Brookhaven National Laboratory
Plant Engineering - E&CS Division
Engineering Change Notice Form

PROJECT: CCWF II

ECN Title: Metal Deck Details

ECN No. 12

EAST AND WEST WALLS

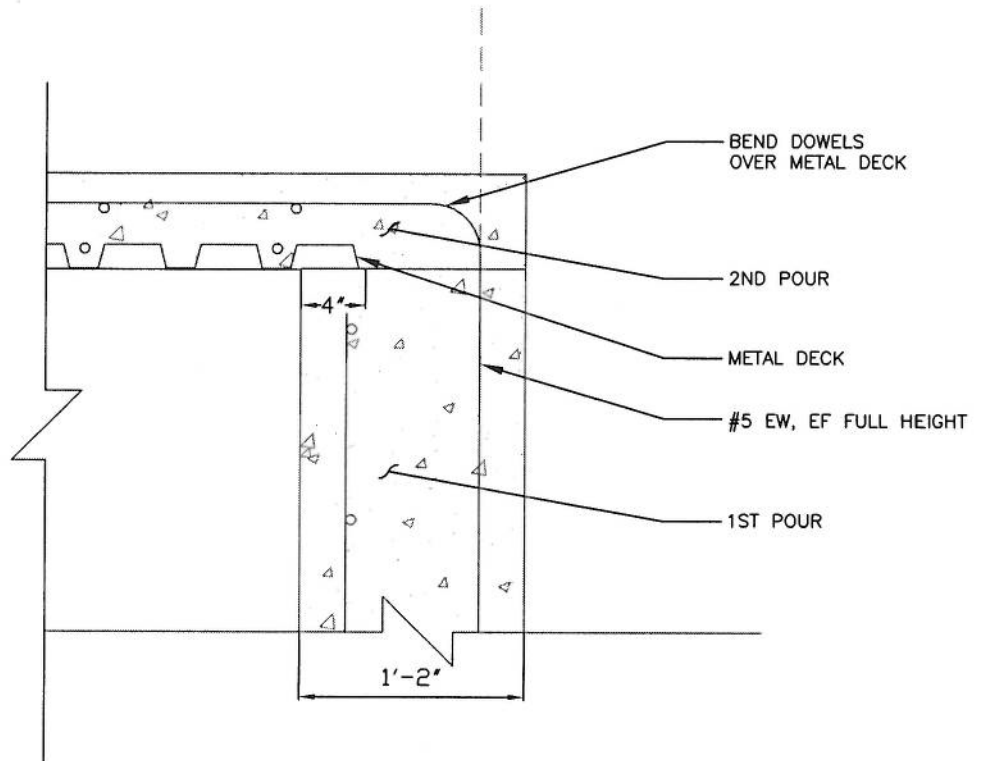
Requested Change (Attach sketch if applicable): The metal decking, on the 2 section details, will have dowels drilled in the foundation wall and sticking up and then they will be bent over the new metal deck before the floor slab gets poured. There will be a 6x6x5/8" angle iron under the new floor deck to support it instead of having the floor deck being poured into the existing foundation wall and chopping that section out. The garage door transition on the South side will be chopped out and dowels will be drilled into the existing foundation wall so when concrete is poured it will be level with the existing angle nosing from the existing garage door transition.

Resolution: Approved. See attached Sketches.
